GROUP CHA	MODEL 2015MY Sedona (YP)
	NUMBER 053 (REV 1, 04/07/2015)	DATE March 2015
TECHNICAL SERVICE BULLETIN		
SUBJECT: SERVICE ACTION: HYDRAULIC STEERING RACK INSPECTION AND/OR REPLACEMENT (SA182)

SUBJECT: SERVICE ACTION: HYDRAULIC STEERING RACK INSPECTION AND/OR REPLACEMENT (SA182)

Reading the Date Code on the Steering Rack
4 J 1 7 (dots)

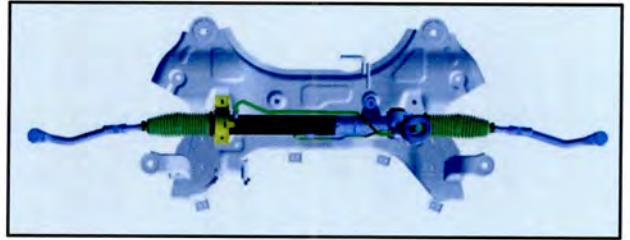
3. If the rack date code matches 4 J 1 7 (dots), replace the rack with an improved part. Proceed to the Service Procedure on Page 3.
4. If the date code is different than 4 J 1 7 (dots), do **NOT** replace the rack. No further action is required.

1. Replace the power steering gear box with an improved one by referring to "Steering System → Hydraulic Power Steering System → Power Steering Gear Box" chapter in the applicable Workshop Manual on KGIS.
2. Perform a front end wheel alignment by referring to "Steering System → Front Suspension System → Front Alignment → Repair procedures" chapter in the applicable Workshop Manual on KGIS.
